# NEXTDC S4

# STATE SIGNIFICANT DEVELOPMENT APPLICATION (SSDA) SUBMISSION

**SSDA MODIFICATION TO THE APPROVED SSDA (SSD-63741210):**

## 1 PROPOSED SITE PLAN SSDA

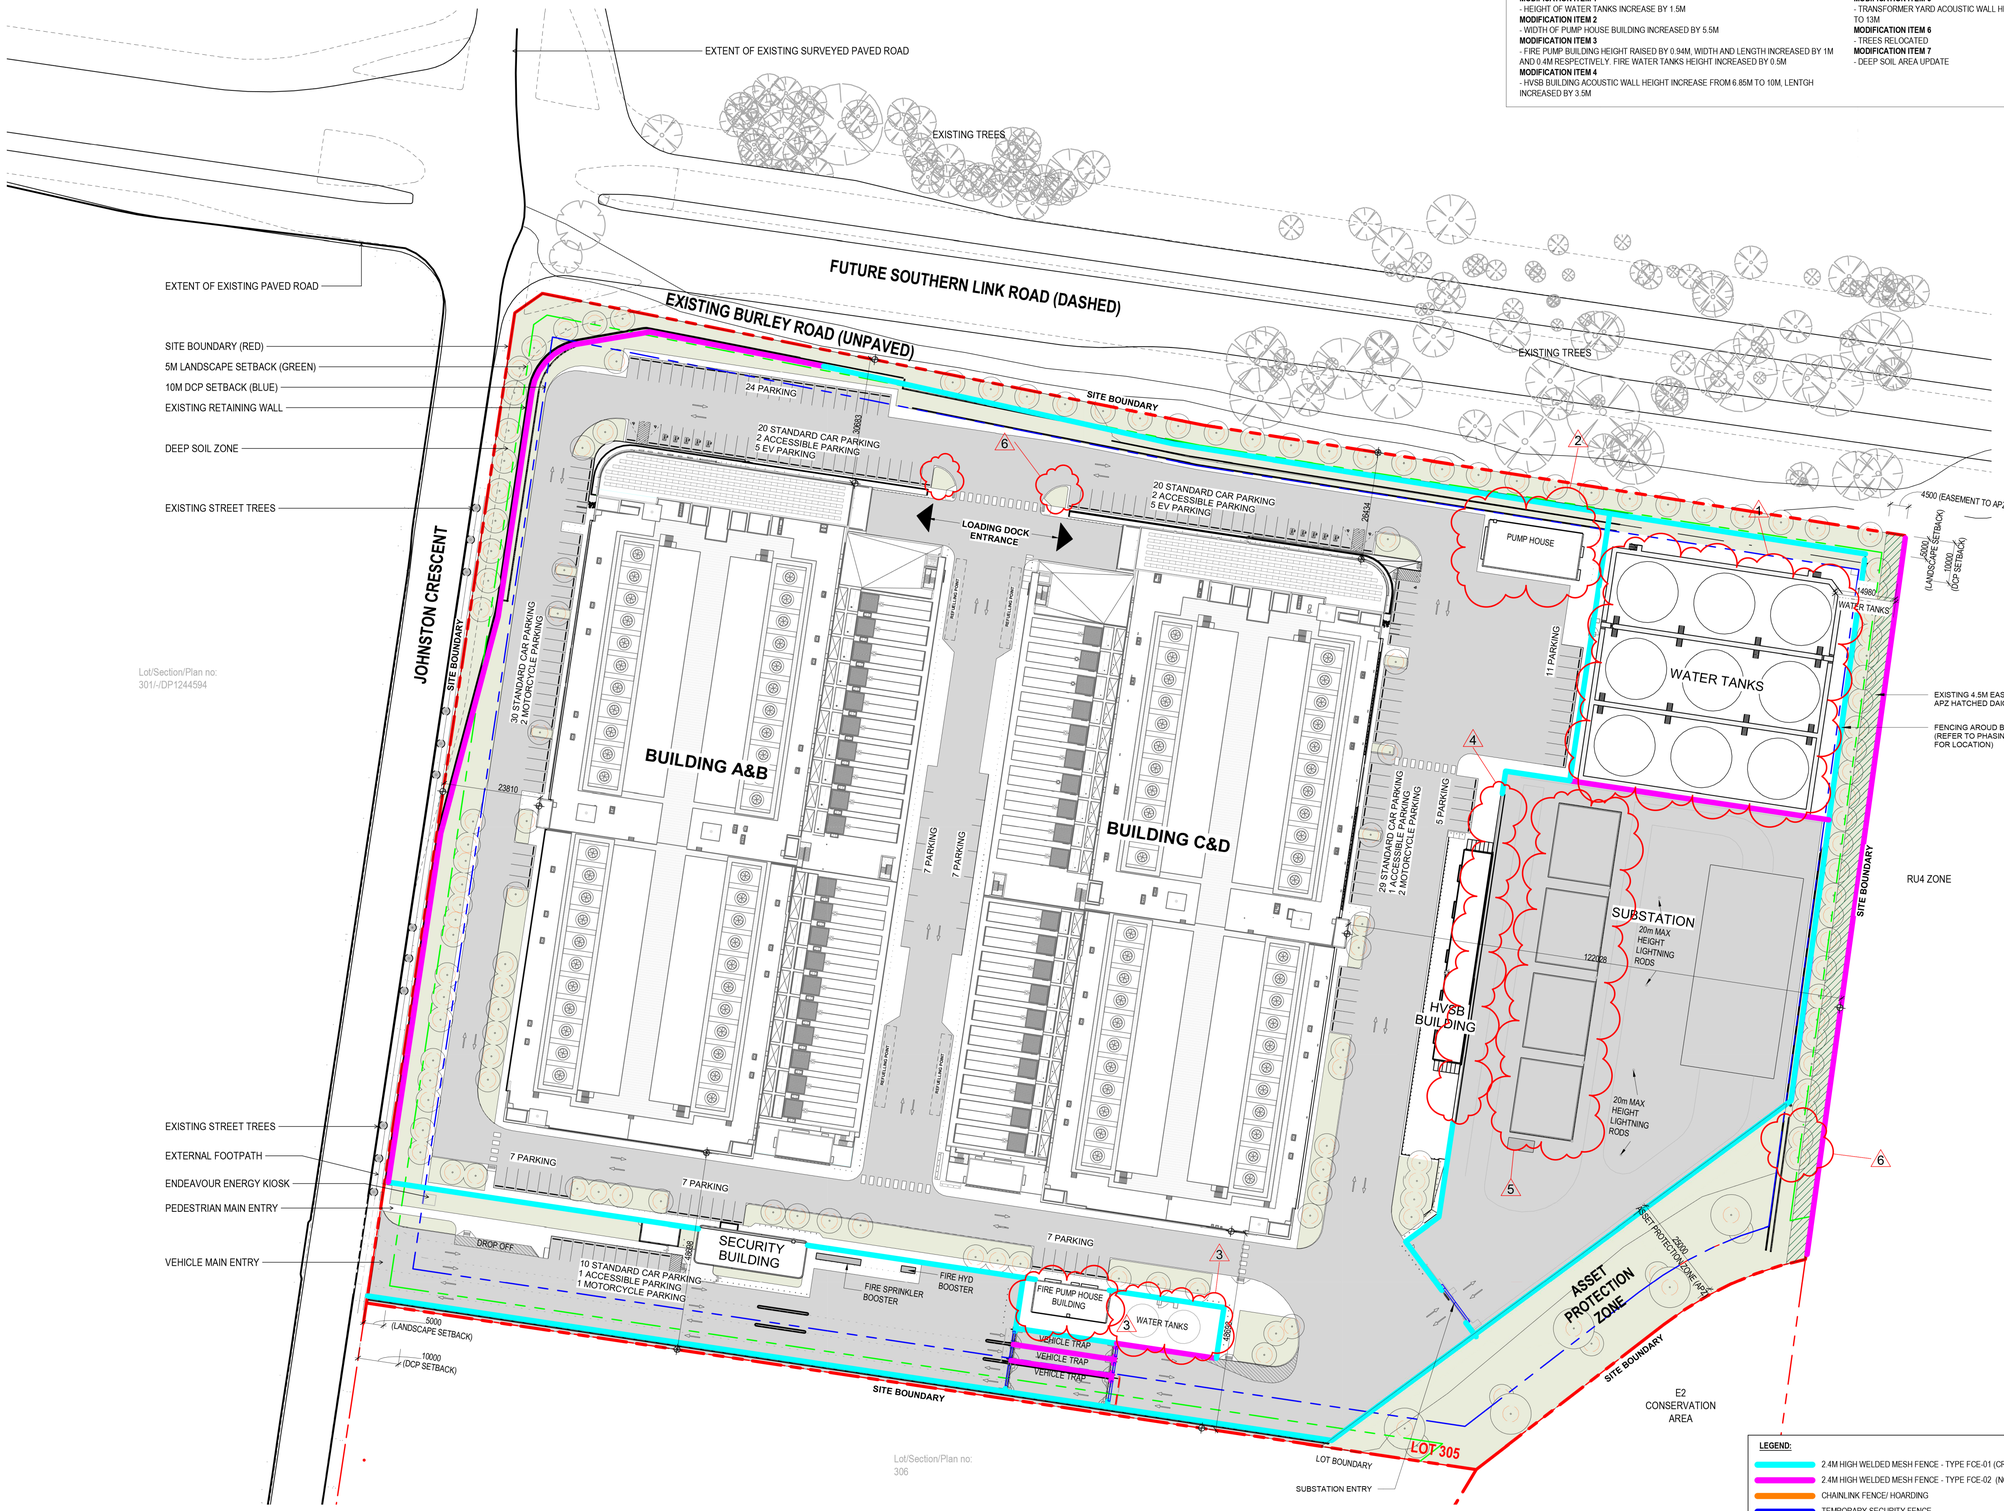
**MODIFICATION ITEM 1**
- HEIGHT OF WATER TANKS INCREASE BY 1.5M

**MODIFICATION ITEM 2**
- WIDTH OF PUMP HOUSE BUILDING INCREASED BY 5.5M

**MODIFICATION ITEM 3**
- FIRE PUMP BUILDING HEIGHT RAISED BY 0.94M, WIDTH AND LENGTH INCREASED BY 1M AND 0.4M RESPECTIVELY. FIRE WATER TANKS HEIGHT INCREASED BY 0.5M

**MODIFICATION ITEM 4**
- HVSB BUILDING ACOUSTIC WALL HEIGHT INCREASE FROM 6.85M TO 10M, LENTGH INCREASED BY 3.5M

**MODIFICATION ITEM 5**
- TRANSFORMER YARD ACOUSTIC WALL HEIGHT INCREASE FROM 10M TO 13M

**MODIFICATION ITEM 6**
- TREES RELOCATED

**MODIFICATION ITEM 7**
- DEEP SOIL AREA UPDATE

## 1 VIEW FROM ADJACENT LOT - PREVIOUS SUBMISSION

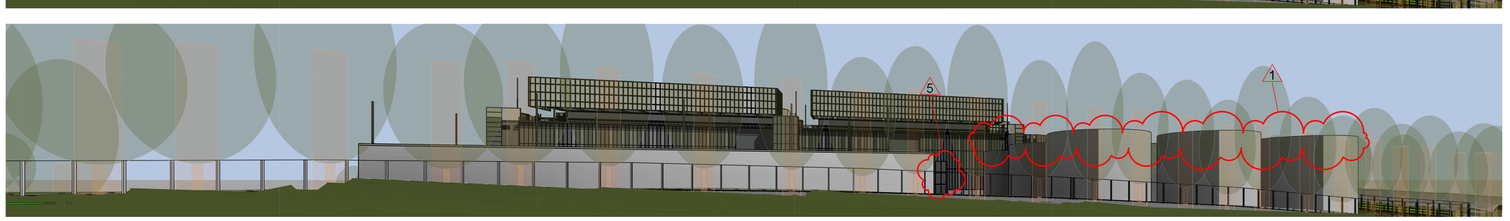
**MODIFICATION ITEM 1**
- HEIGHT OF WATER TANKS INCREASE BY 1.5M

**MODIFICATION ITEM 2**
- WIDTH OF PUMP HOUSE BUILDING INCREASED BY 5.5M

**MODIFICATION ITEM 3**
- FIRE PUMP BUILDING HEIGHT RAISED BY 0.94M, WIDTH AND LENGTH INCREASED BY 1M AND 0.4M RESPECTIVELY. FIRE WATER TANKS HEIGHT INCREASED BY 0.5M

**MODIFICATION ITEM 4**
- HVSB BUILDING ACOUSTIC WALL HEIGHT INCREASE FROM 6.85M TO 10M, LENTGH INCREASED BY 3.5M

**MODIFICATION ITEM 5**
- TRANSFORMER YARD ACOUSTIC WALL HEIGHT INCREASE FROM 10M TO 13M

**MODIFICATION ITEM 6**
- TREES RELOCATED

**MODIFICATION ITEM 7**
- DEEP SOIL AREA UPDATE

Drawing Title: SITE WIDE SSDA SHADOW DIAGRAMS

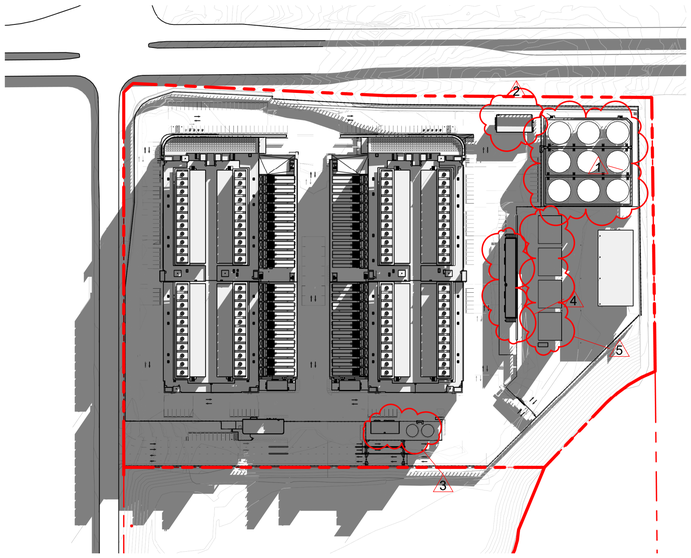
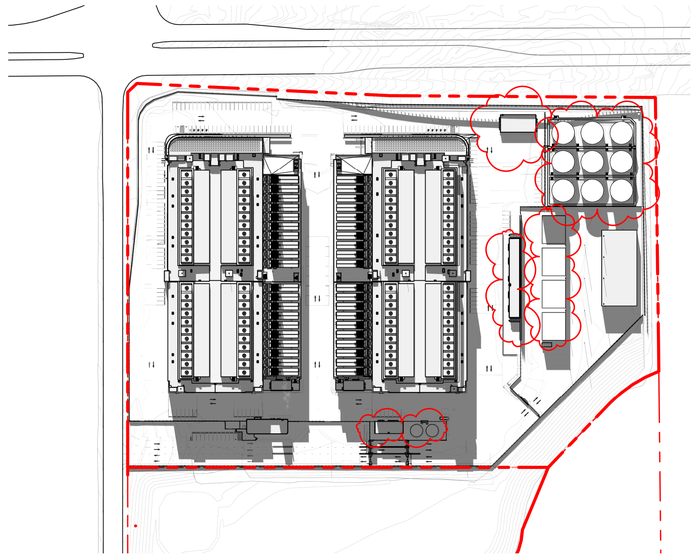
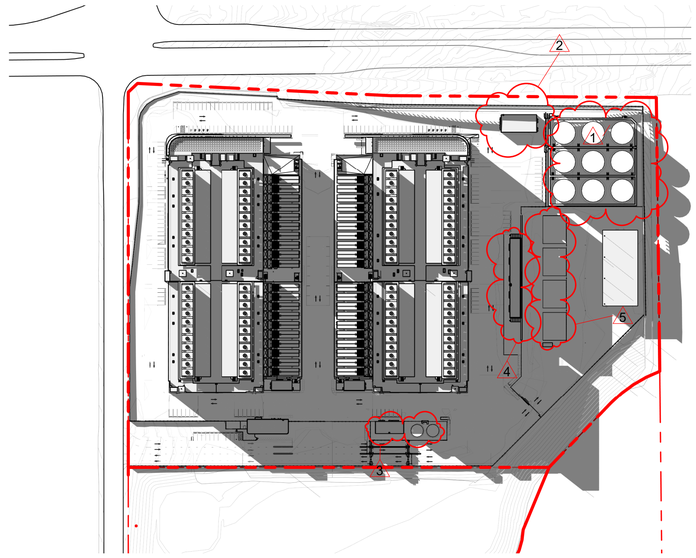
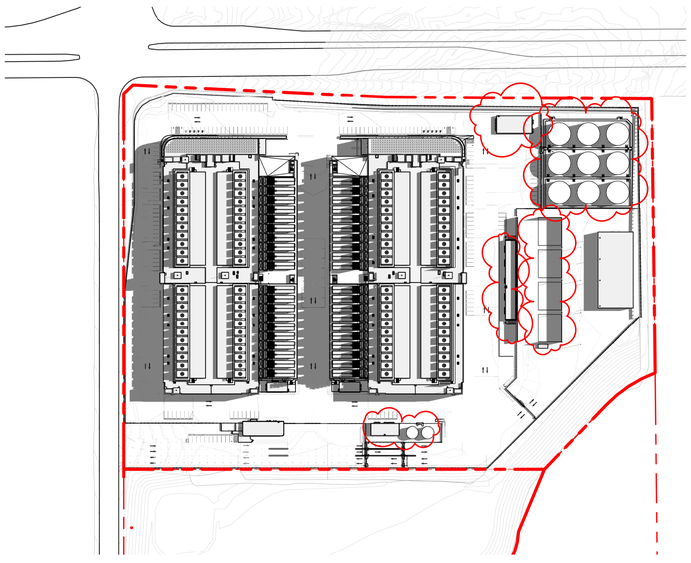
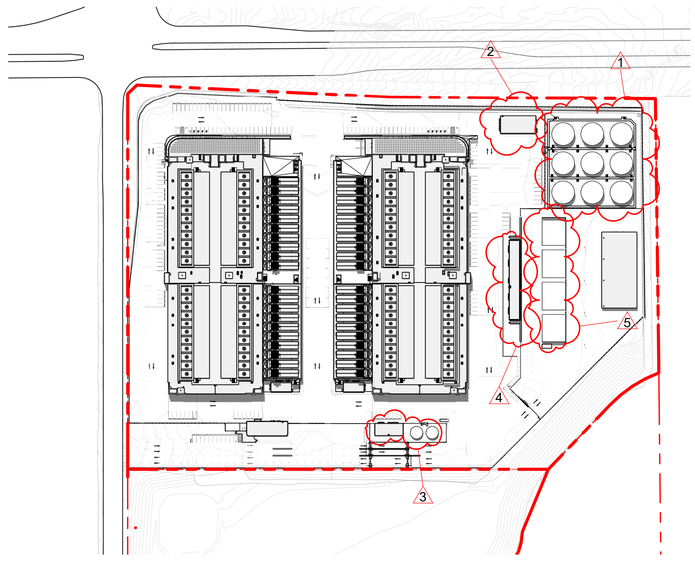
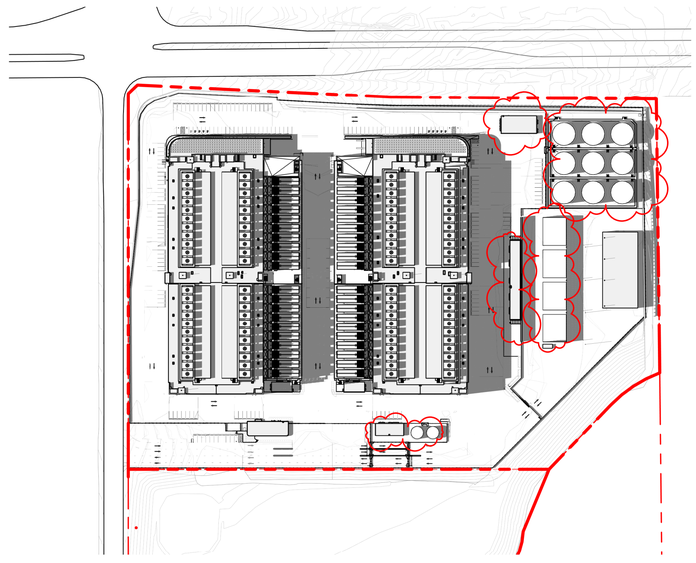
**MODIFICATION ITEM 1**
- HEIGHT OF WATER TANKS INCREASE BY 1.5M

**MODIFICATION ITEM 2**
- WIDTH OF PUMP HOUSE BUILDING INCREASED BY 5.5M

**MODIFICATION ITEM 3**
- FIRE PUMP BUILDING HEIGHT RAISED BY 0.94M, WIDTH AND LENGTH INCREASED BY 1M AND 0.4M RESPECTIVELY. FIRE WATER TANKS HEIGHT INCREASED BY 0.5M

**MODIFICATION ITEM 4**
- HVSB BUILDING ACOUSTIC WALL HEIGHT INCREASE FROM 6.85M TO 10M, LENTGH INCREASED BY 3.5M

**MODIFICATION ITEM 5**
- TRANSFORMER YARD ACOUSTIC WALL HEIGHT INCREASE FROM 10M TO 13M

**MODIFICATION ITEM 6**
- TREES RELOCATED

**MODIFICATION ITEM 7**
- DEEP SOIL AREA UPDATE

Drawing Title:
SITE WIDE
SSDA PHASING DIAGRAM
STAGES 1 - 4

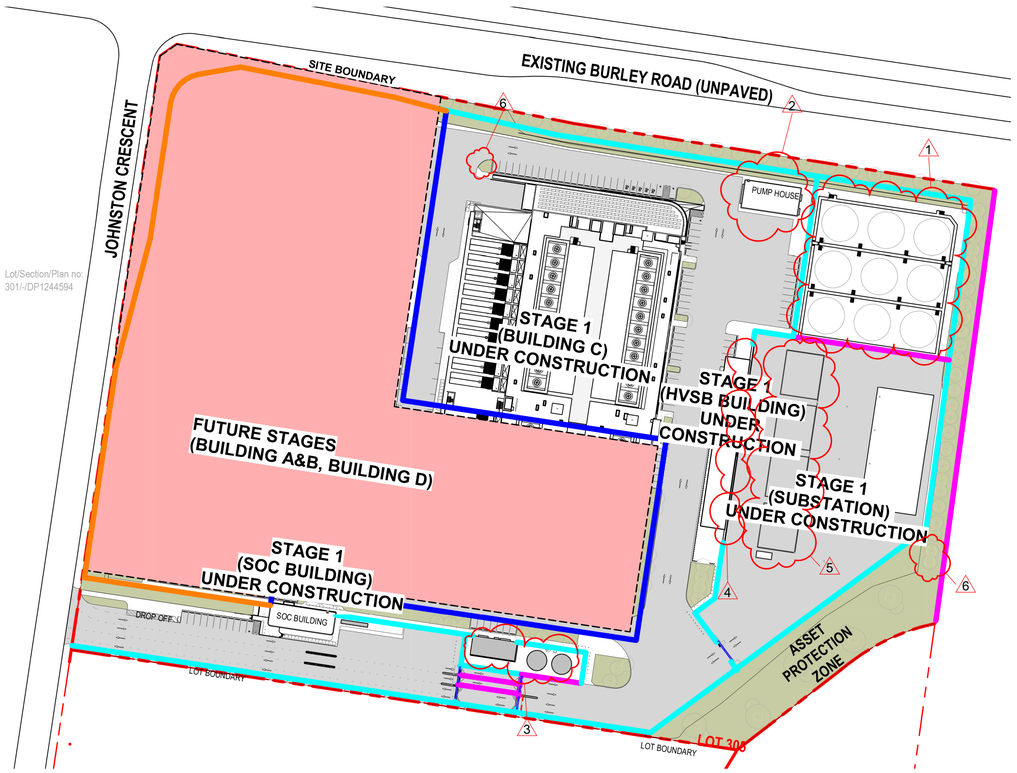
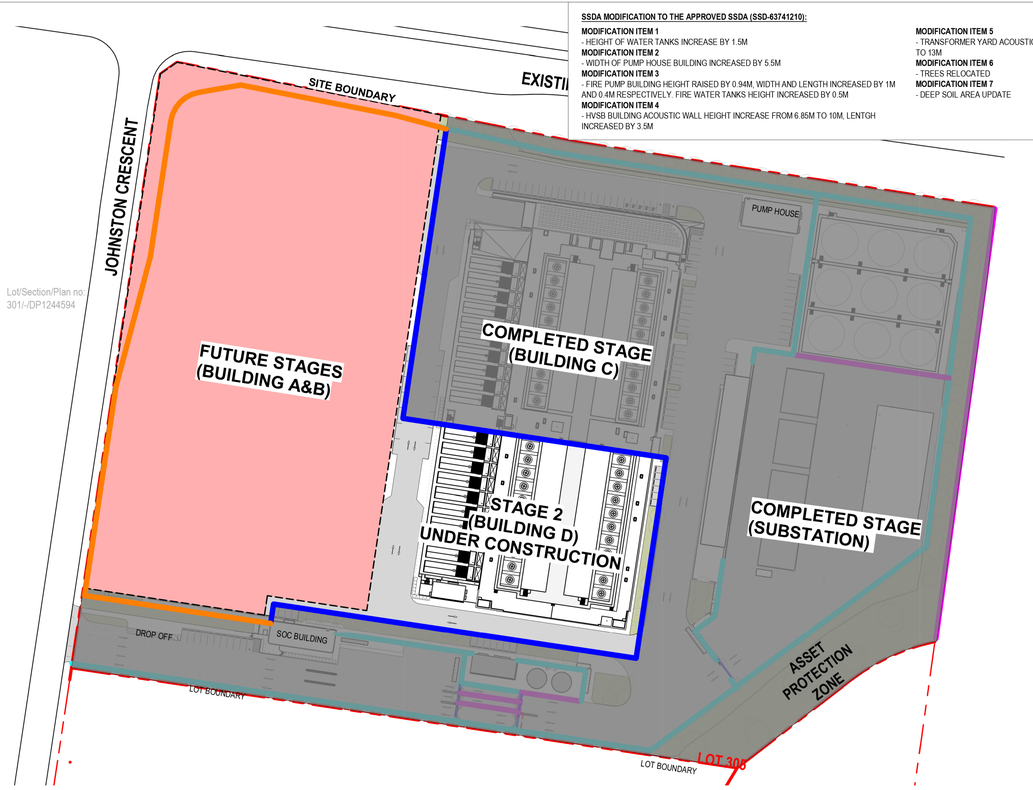
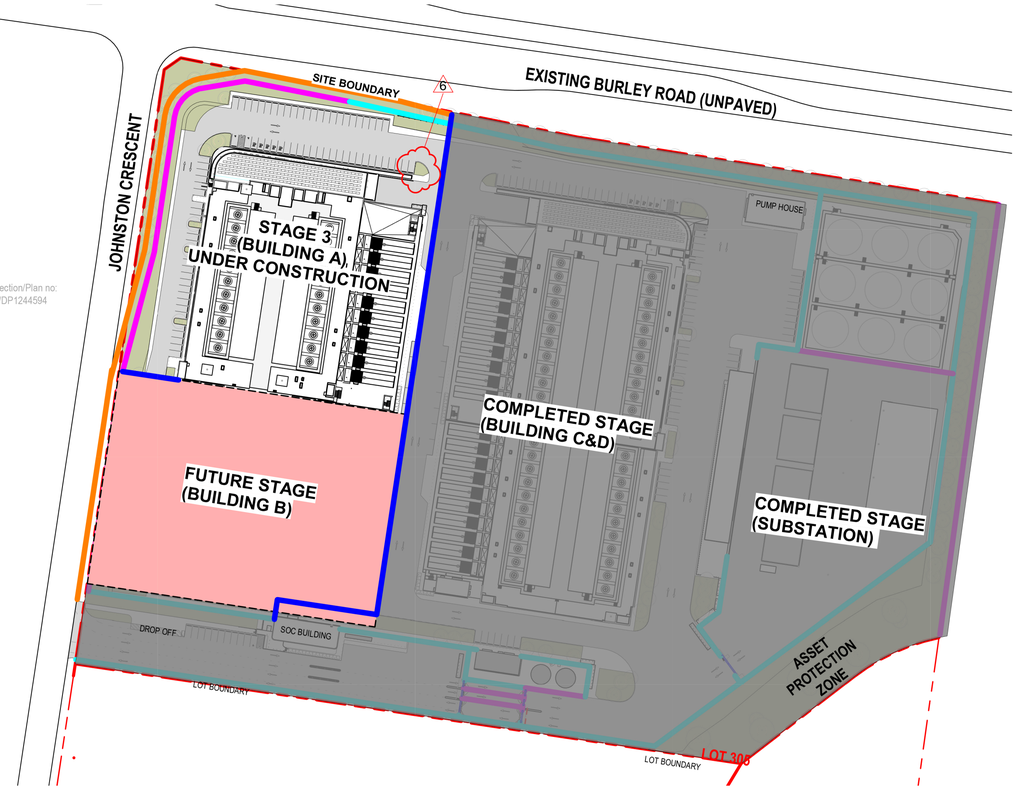
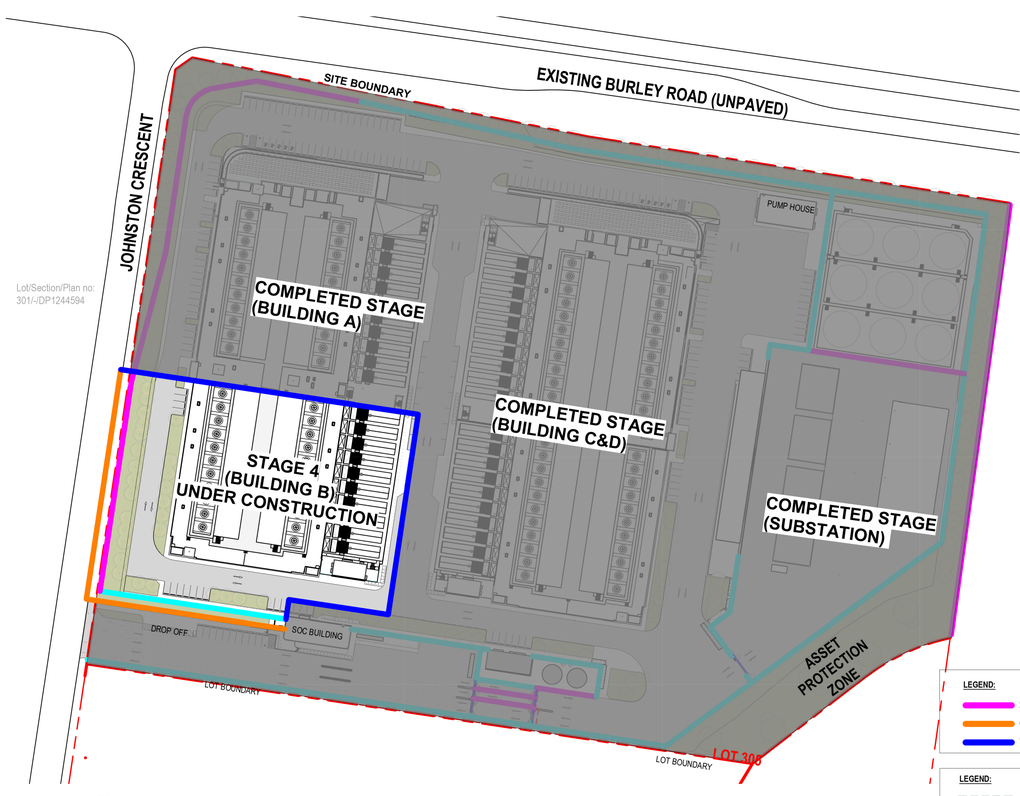
**MODIFICATION ITEM 1**
- HEIGHT OF WATER TANKS INCREASE BY 1.5M

**MODIFICATION ITEM 2**
- WIDTH OF PUMP HOUSE BUILDING INCREASED BY 5.5M

**MODIFICATION ITEM 3**
- FIRE PUMP BUILDING HEIGHT RAISED BY 0.94M, WIDTH AND LENGTH INCREASED BY 1M AND 0.4M RESPECTIVELY. FIRE WATER TANKS HEIGHT INCREASED BY 0.5M

**MODIFICATION ITEM 4**
- HVSB BUILDING ACOUSTIC WALL HEIGHT INCREASE FROM 6.85M TO 10M, LENTGH INCREASED BY 3.5M

**MODIFICATION ITEM 5**
- TRANSFORMER YARD ACOUSTIC WALL HEIGHT INCREASE FROM 10M TO 13M

**MODIFICATION ITEM 6**
- TREES RELOCATED

**MODIFICATION ITEM 7**
- DEEP SOIL AREA UPDATE
